New Albany Planning Commission
Informal Meeting Minutes Monday, May 5, 2025 - Approved

FDP-05-2025 AEP Substation

Final development plan to allow for construction of an AEP electrical substation on 9.50 acres located at 7375 Souder Road (PID: 222-002282).

**AEP SUBSTATION
FINAL DEVELOPMENT PLAN**

CONCEPTUAL LANDSCAPE PLAN
SHEET 1 OF 3

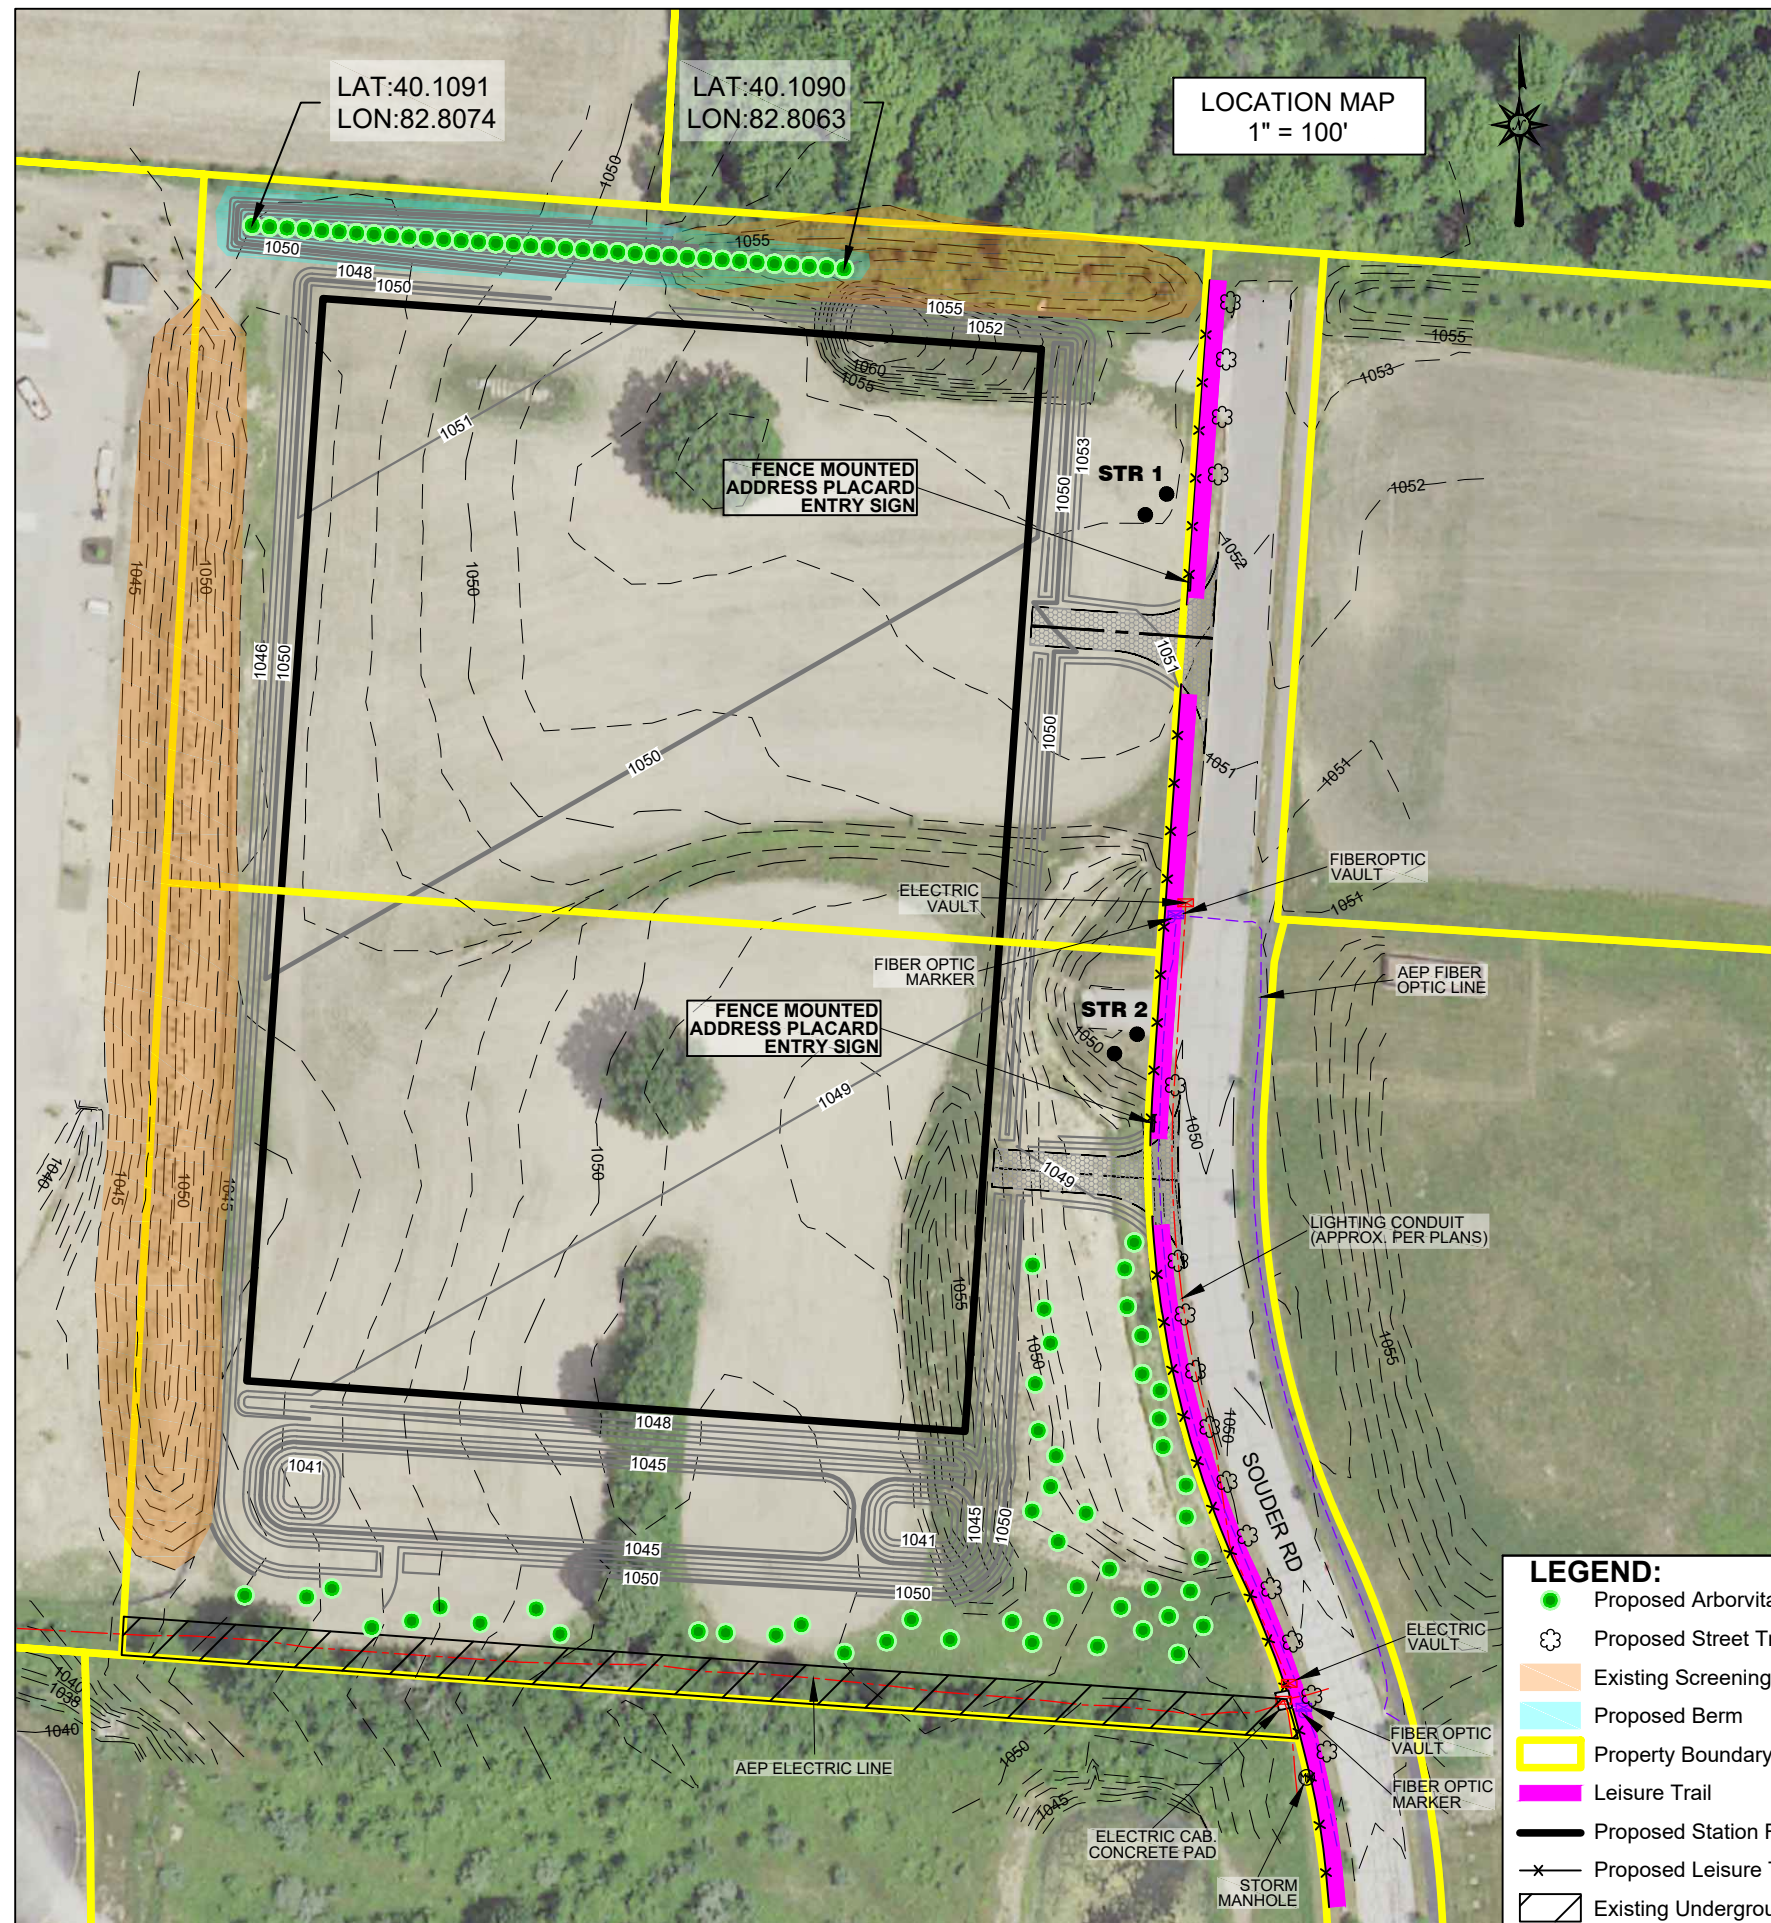
2. ☐ The New Albany Business Park Research and Information Campus Design Guidelines require 15 trees per 100 linear feet to be planted along Souder Road however, the applicant is not able to do so due to the utility corridor. In lieu of providing this landscaping on Souder Road, staff recommend a condition of approval that the applicant include naturalized plantings in the northwest corner of the site to provide additional screening (condition #1)

1. ☐ That the applicant includes naturalized plantings in the northwest corner of the site to provide additional screening
2. ☐ Engineering staff will evaluate storm water management, water distribution, sanitary sewer collection and roadway construction related details once construction plans become available.
